EDWIN TOWNSEND'S SUBDIVISION NO.1, IN LOT 3
OF FIRST DIVISION OF MCVOY TRACT,
RESUBDIVISION OF THE EAST 211 FEET OF LOT 1

APPLICATION NUMBER 9 DATE October 6, 2011

REQUEST Subdivision

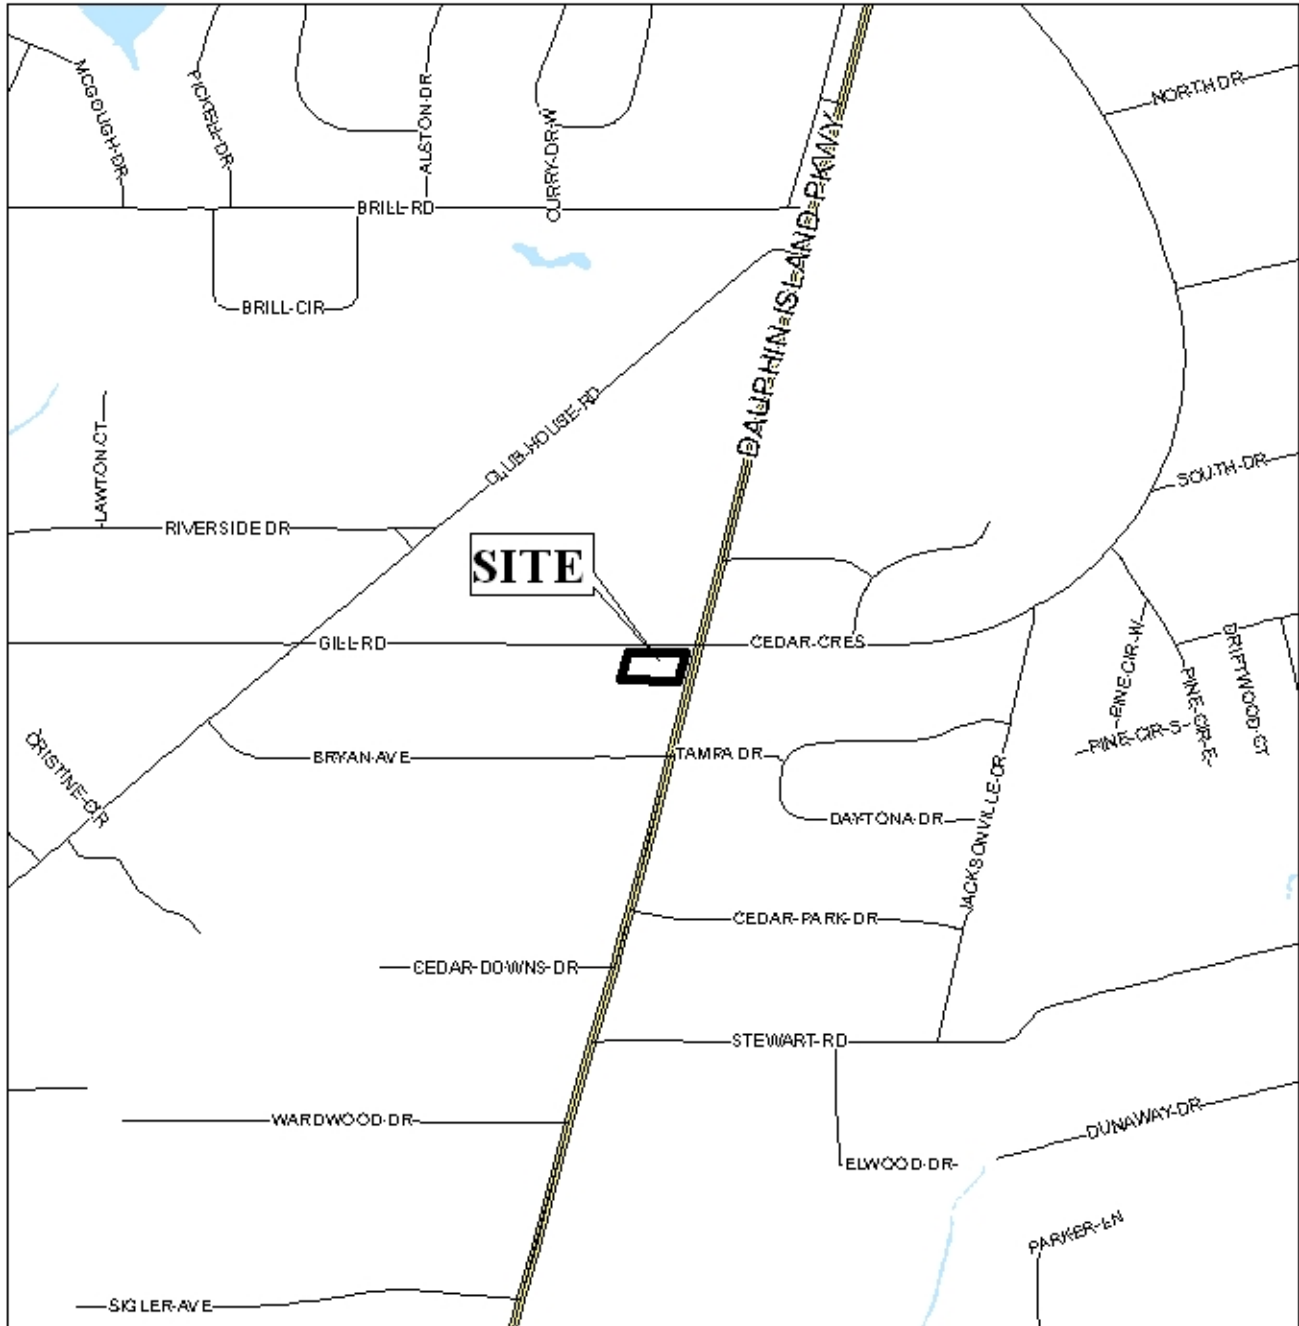
The site fronts Dauphin Island Parkway and Gill Road. Dauphin Island Parkway is a component of the Major Street Plan with a planned 100' right-of-way. As the plat indicates an existing 120' right-of-way in this area, no dedication would be required, except at the street corner. Gill Road is indicated to have a compliant 60' right-of-way; therefore, no dedication would be required along it, either, except at the street corner. Dedication should be required at the intersection of Dauphin Island Parkway and Gill Road to provide a 25' minimum corner radius. The 25' minimum building setback line is illustrated along Dauphin Island Parkway on the preliminary plat but not along Gill Road. Therefore, the plat should be revised to illustrate the 25' minimum building setback line along both Dauphin Island Parkway and Gill Road.

A condition of approval for the rezoning of the property is that the site be "limited to one curb cut to Dauphin Island Parkway, and one curb cut to Gill Road to be approved by Traffic Engineering". This should also be a condition for the Subdivision, if approved, modified to include the current Traffic Engineering comments.

As on the preliminary plat, the Final Plat should label the lot with its size in both square feet and acres after any required dedication, or a table should be furnished on the Final Plat providing the same information.

- 1) dedication to provide a 25' minimum corner radius at the intersection of Dauphin Island Parkway and Gill Road;
- 2) revision of the plat to indicate the 25' minimum building setback line along both Dauphin Island Parkway and Gill Road;

- 3) placement of a note on the Final Plat stating that the subdivision is limited to one curb cut to Dauphin Island Parkway, to be approved by ALDOT, and one curb cut to Gill Road, with the size, location, and design to be approved by Traffic Engineering and conform to AASHTO standards;

- 4) revision of the plat to label the lot with its size in square feet and acres after any required street dedication, or the furnishing of a table on the Final Plat providing the same information;
